TUTHILL SUBDIVISION, LONG ADDITION TO

APPLICATION NUMBER 2 DATE November 19, 2009
 APPLICANT Tuthill Subdivision, Long Addition to
 REQUEST Subdivision

DETAIL SITE PLAN

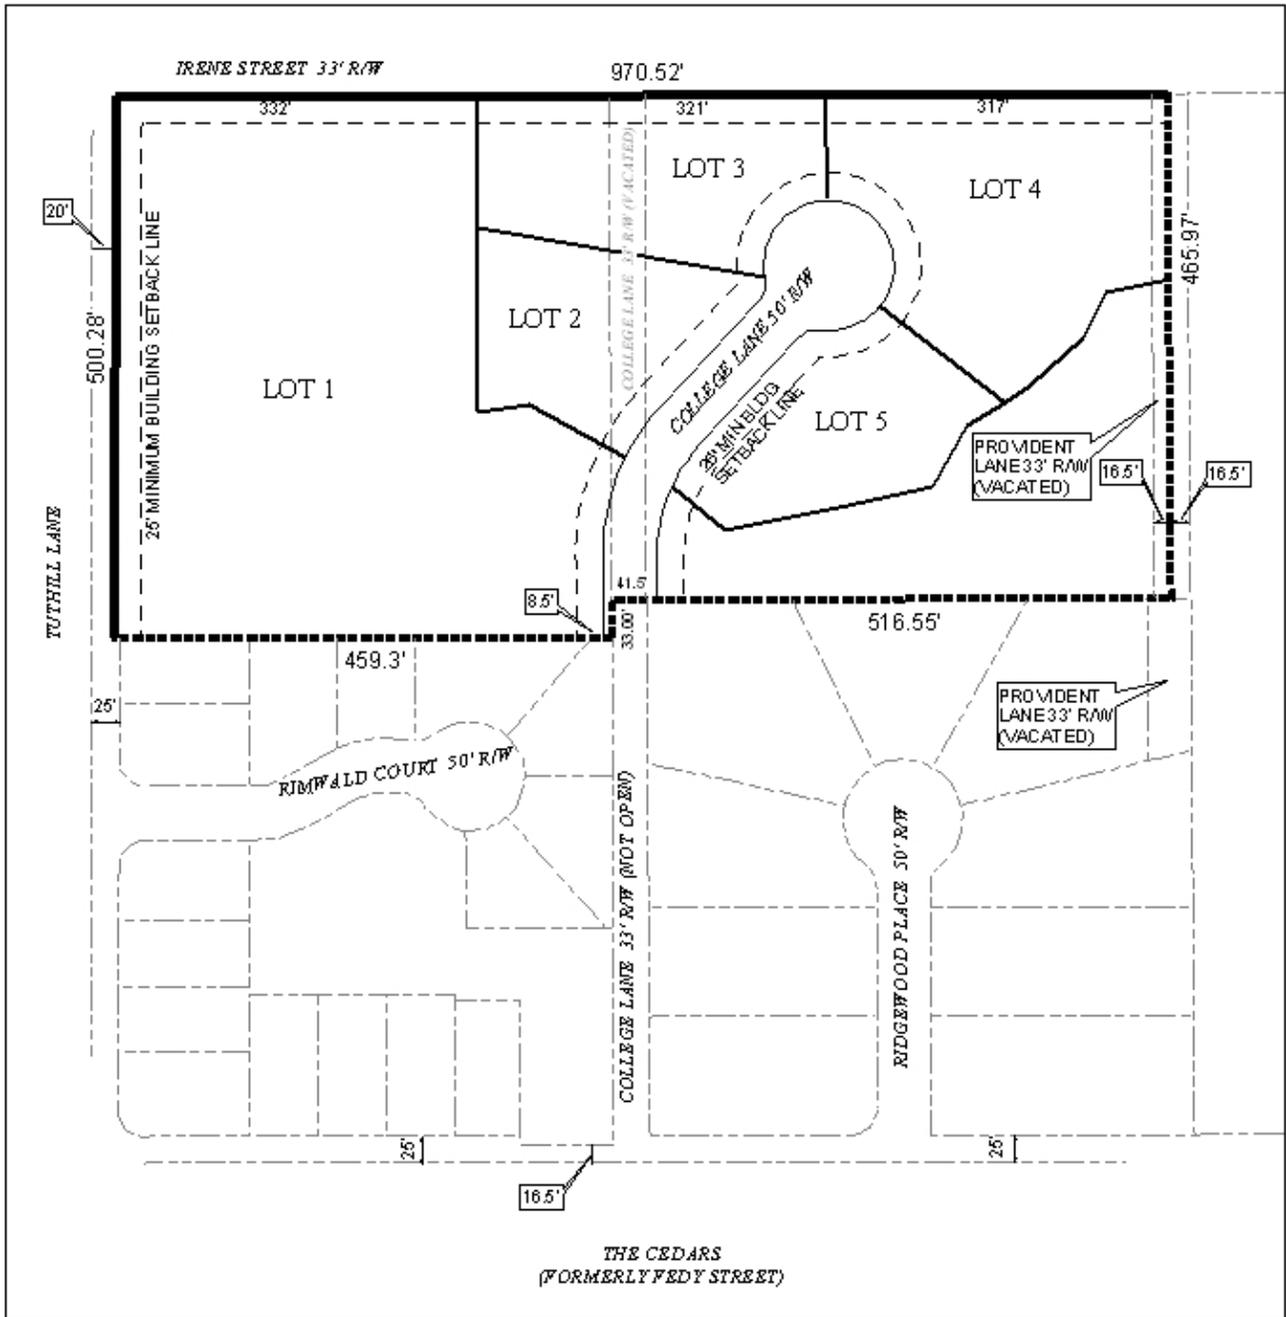
The applicants propose to construct a development which connects to the existing unopened right-of-way of College Lane. The plat depicts the proposed new right-of-way of College Lane on the site as 50 feet which will connect to the existing, unopened right-of-way, depicted as being only 33 feet. Section V.B.14 of the Subdivision Regulations requires a minimum right-of-way width for minor streets provided with curb and gutter to be 50 feet.

Properties on either side of the existing right-of-way are already developed with dwellings. As none of these properties are included in this application, it appears that the applicant intends to construct a city-standard street on a sub-standard right of way. Additionally, the existing College Street right-of-way as well as the proposed extension would result in a closed-end street longer than 600-feet, in violation of Section V.B.6 of the Subdivision Regulations. It should be noted that the existing 33-foot right-of-way of College Lane is also insufficient under the Village of Springhill Traditional Center District regulations.

Without a dedication of each property owner along the existing College Lane right-of-way, together with inclusion of the said properties in the subdivision, the proposed subdivision would have inadequate access. It should be noted that if the applicant were to include the requisite lots to obtain necessary right-of-way, the application would need to include Lots 4-6 of Rimwald Court Subdivision (MB 35, Page 47), the metes and bounds parcel at the Northwest corner of where the College Lane right-of-way and The Cedars meet, Lot 6 of Ridgewood Revised Lot 6 Subdivision (MB 68, Page 8), Lots 7-8 of Ridgewood Subdivision (MB 5, Pages 219-221), and Lot 9 of Ridgewood Subdivision, Resubdivision of Lot 9. Further, each of these lots would be required to dedicate enough right-of-way to provide 25 feet from the centerline of College Lane.

Based on the previously stated information, if access to the subdivision is only provided via the substandard right-of-way of College Lane, access will not be adequate as per Section V.B.14 of the Subdivision Regulations. An alternative for the applicant to consider would be revising the configuration so that the subdivision is accessed from Tuthill Lane via Irene Street (with proper right-of-way dedication), and access to The Cedars eliminated, except for a street stub connecting to the unopened right-of-way.

Finally, the applicant is indicating that the proposed Lot 1 would cross the proposed College Lane extension. Lots cannot cross rights-of-way, and therefore, this should also be revised to reflect an additional lot in the subdivision, and this lot would also have to meet all lot regulations.

- 1) The proposed subdivision would have inadequate access due to substandard rights-of-way for both College Lane and Irene Street as per Section V.B.14 of the Subdivision Regulations;
- 2) The proposed extension to College Lane would create a closed-end street longer than 600 feet and thus not in compliance with Section V.B.6 of the Subdivision Regulations;
- 3) The proposed Lot 1 crosses a public right-of-way; and
- 4) The comments made by City Engineering: *The City of Mobile Engineering Department is in opposition to the subdivision as proposed for the several reasons. A minimum ROW width of 50 feet will be required for the entire length of College Lane. Due to the*
